STAFF RECOMMENDATION
2516 Belmont Boulevard
September 16, 2020

Application: Violation/Show Cause; New Construction—Outbuilding; Setback Determination
District: Belmont-Hillsboro Neighborhood Conservation Zoning Overlay
Council District: 18
Base Zoning: R8
Map and Parcel Number: 11704003700
Applicant: Brad Van Rassel, Architect
Project Lead: Sean Alexander, sean.alexander@nashville.gov

<p>Description of Project: Staff has ordered a Show Cause hearing for an outbuilding that was not constructed in accordance with the approved design, which intrudes into the street-facing setback area. A balcony that was not on the approved plans has been added to the street-facing elevation of the building.</p> <p>The applicant is required to appear before the Commission and show cause as to why the work should be allowed to remain as-is, rather than corrected as per the original Preservation Permit.</p> <p>Recommendation Summary: Staff recommends that the violation be corrected to meet the previously approved plans, finding that the balcony does not meet section II.B.1.i of the <i>Belmont-Hillsboro Neighborhood Conservation Zoning Overlay: Handbook and Design Guidelines</i>. Staff further recommen

1 SWEETBRIAR ELEVATION
1/8" = 1'-0"

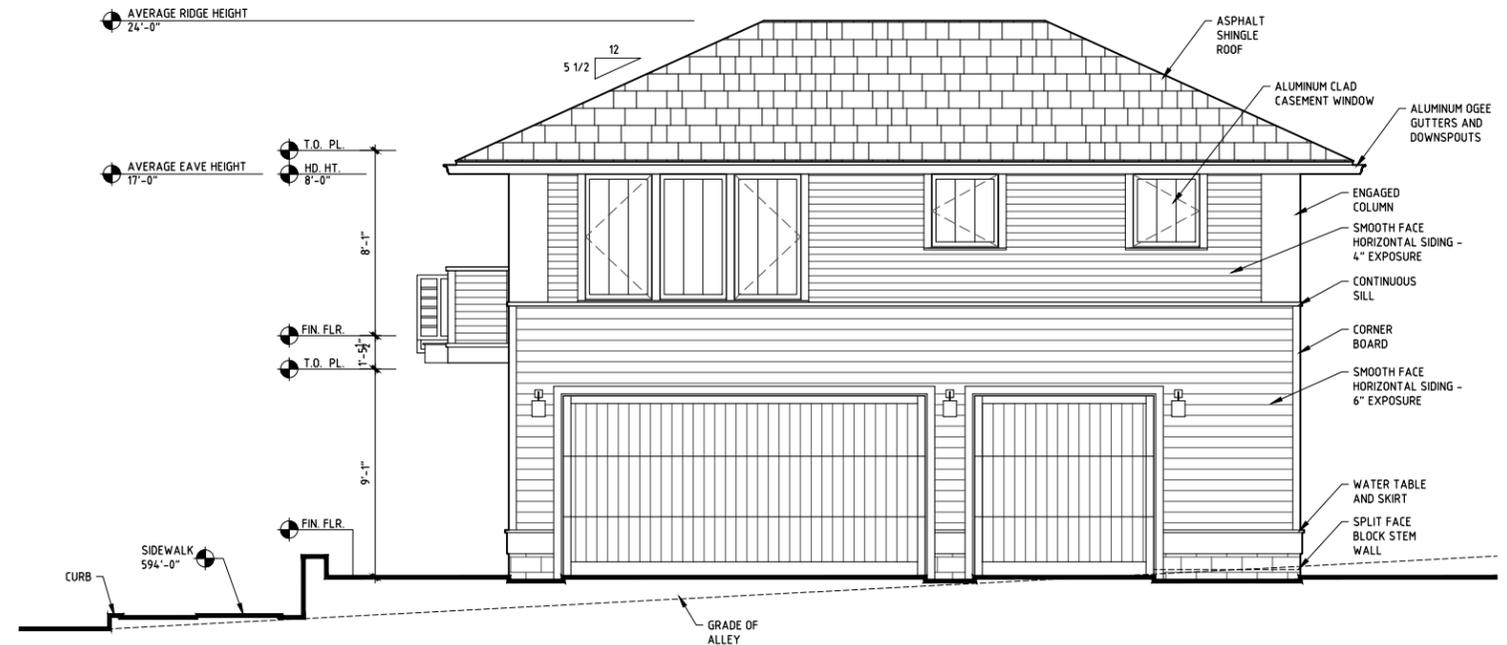
The bulk zoning regulations require outbuildings on corner lots to be at least ten feet (10') from the property line adjacent to the side street, and balconies are not permitted to project over a standard setback buffer. The balcony constructed on the 2516 Belmont Boulevard outbuilding projects three feet, six inches (3'-6") into the standard setback buffer. The MHZC has the authority to determine different setbacks for buildings in historic overlays, when doing so is appropriate and consistent with the surrounding historic context. Balconies are not typical features on outbuildings historically, therefore staff does not find that a shorter setback is justified to accommodate the balcony facing Sweetbriar Avenue.

Staff finds that the balcony does not meet section II.B.1.i.2. of the design guidelines for setbacks.

Recommendation: Staff recommends that the violation be corrected to meet the previously approved plans, finding that the balcony does not meet section II.B.1.i of the *Belmont-Hillsboro Neighborhood Conservation Zoning Overlay: Handbook and Design Guidelines*. Staff further recommends that the balcony be removed within sixty (60) days.
